# Access Compliance Report

## Public Rights-of-Way

### (Curb Ramps)

| Intersection ID: 10033986 | Main Street: PARK_RD | Cross Street: N/A       | Location: SE           |

| ADA ID: 0AF59FE7FA23      | Ramp Type: PerpDiag  | Initial Pass/Fail: Fail | Overall Compliance: No |

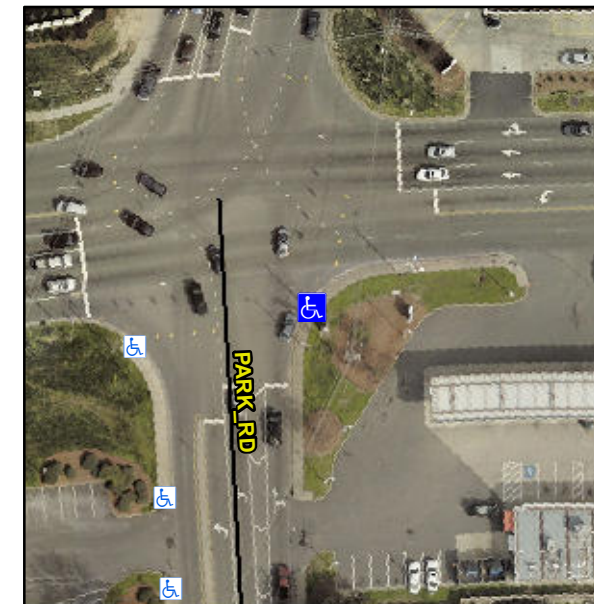
**Not Found, R304.5.1, R304.2.2, R304.5.3**

| Compliance | Description           | Data | Compliance | Description                 | Data |
|------------|-----------------------|------|------------|-----------------------------|------|
| N/A        | Ramp Length (in)      | 62.0 | No         | Ramp Slope (%)              | 10.6 |
| No         | Ramp Width (in)       | 36.0 | No         | Ramp XSlope (%)             | 3.5  |

**Remove & Replace Curb Ramp With Two New Directional Ramps or Equivalent.**
